APPLICATION NO.	FILING DATE	FIRST NAMED INVENTOR	ATTORNEY DOCKET NO.	CONFIRMATION NO.
10/642,454	08/13/2003	Eugene P. Marsh	MI22-2382	2187

Office Action Summary

DETAILED ACTION

Attachment

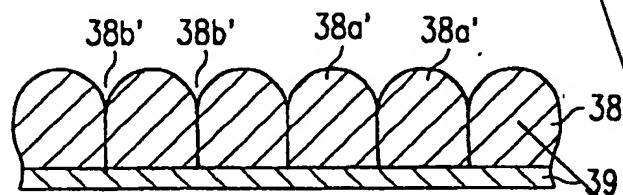
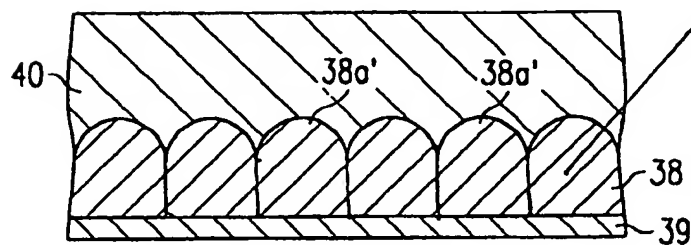
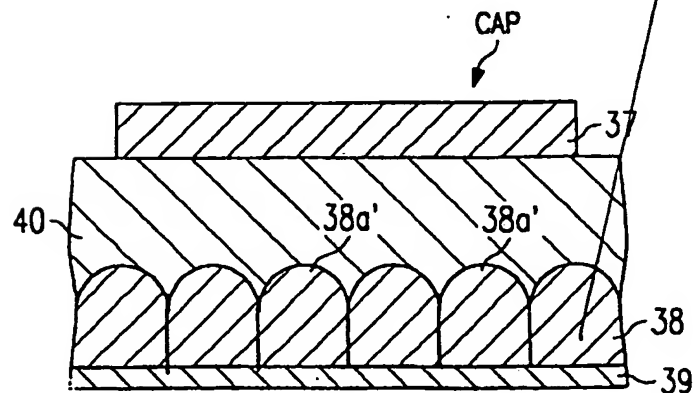
a roughened platinum layer (38), the roughened platinum layer comprises columnar platinum pedestals terminating in dome-shaped tops. Note Figures 1A-14 (especially Figures 1B-1D) of Aoki et al.. See Attachment

Regarding claim 33, Aoki et al. discloses the roughened platinum layer (32,112) has a continuous surface characterized by columnar platinum pedestals, wherein the column platinum pedestals have heights greater than or equal to about one-third of a total thickness of the roughened platinum. Note Figures 1A-14 (especially Figures 1B-1D) of Aoki et al..

Regarding claim 40, Aoki et al. discloses, as shown in Figures 1A-14 (especially Figures 1B-1D), a capacitor comprising:

wherein at least one of the first and second capacitor electrodes comprise roughened platinum, the roughened platinum having a continuous surface characterized by columnar pedestals having heights greater than or equal to about one-third of a total thickness of the roughened platinum. Note Figures 1A-14 (especially Figures 1B-1D) of Aoki et al..
